SUBJECT: MTA CONSTRUCTION NONCONFORMANCE REPORTS

Attached please find copies of the Nonconformance Reports (NCRs) received by the MTA Director of Quality Management for the period of January 19-25, 1996.

Nonconformance Report

CONTRACT NO. 241
 VERMONT/BEVERLY STATION
 AS BUILT OF 12X12 RESHORES FOR
 CENTER MEZZANINE AT TRACK
 LEVEL, AS OF 1/8/96

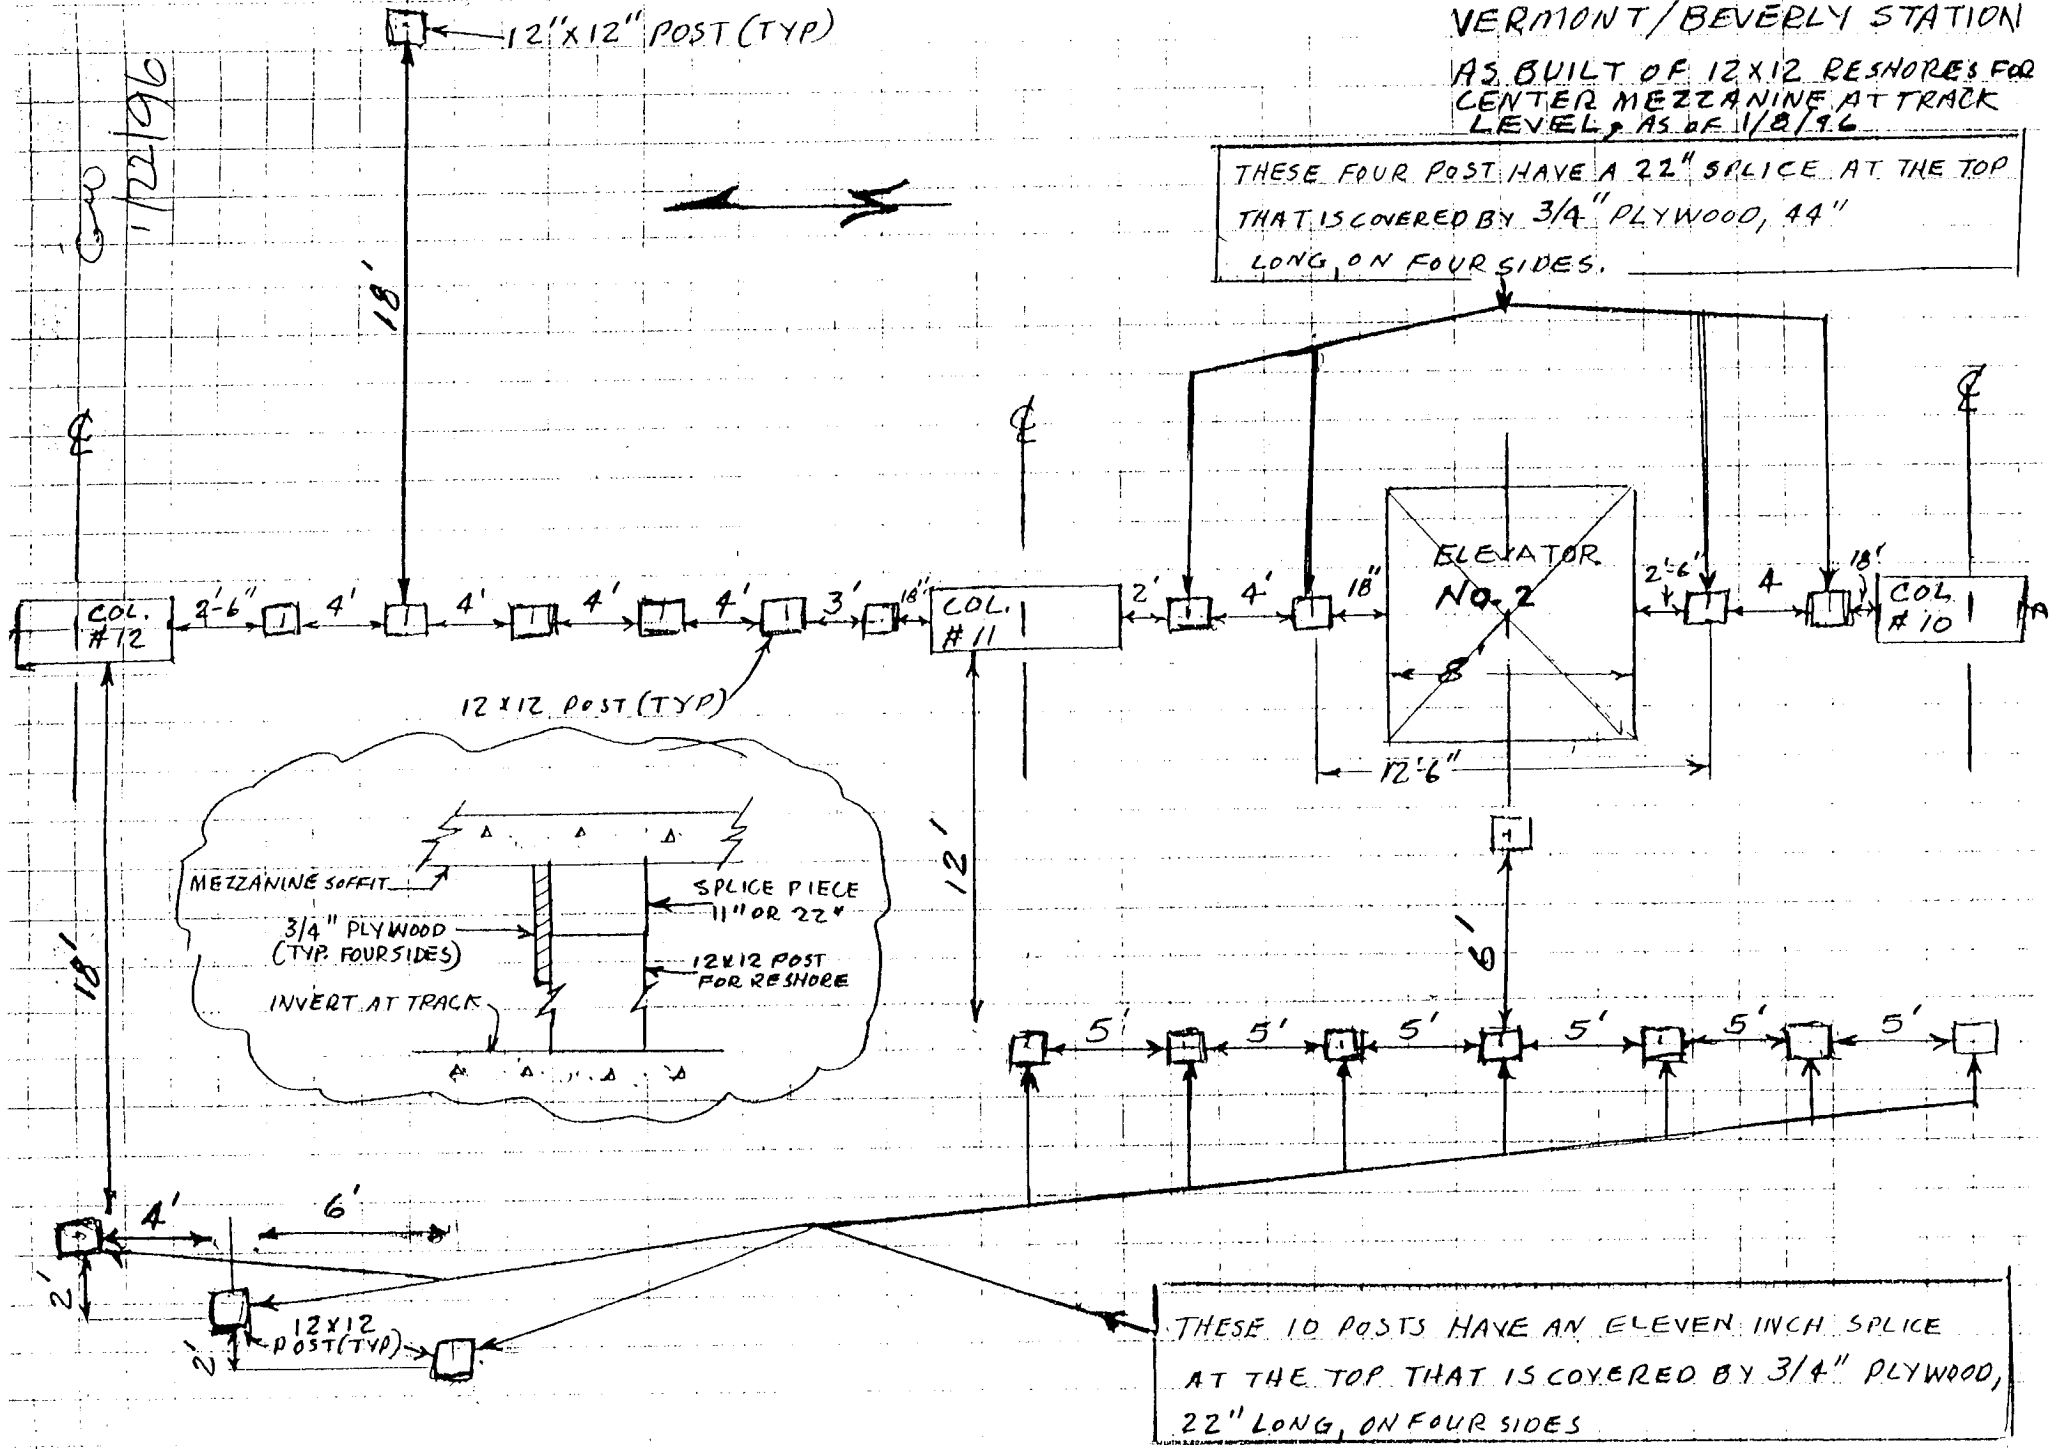
9. Contract requirement : Substitutions in methods of construction shall be submitted in accordance with the provisions of specification section 01300. This shall include detailed description of proposed methods and working drawings illustrating the methods. Non-conformance Description: The contractor has spliced several reshore timbers under the center mezzanine level. The splicing details were not submitted on the original submittal and, to date, have not been submitted for approval. See attached sketch for locations.

THESE FOUR POST HAVE A 22" SPLICE AT THE TOP
 THAT IS COVERED BY 3/4" PLYWOOD, 44"
 LONG, ON FOUR SIDES.

THESE 10 POSTS HAVE AN ELEVEN INCH SPLICE
 AT THE TOP THAT IS COVERED BY 3/4" PLYWOOD,
 22" LONG, ON FOUR SIDES
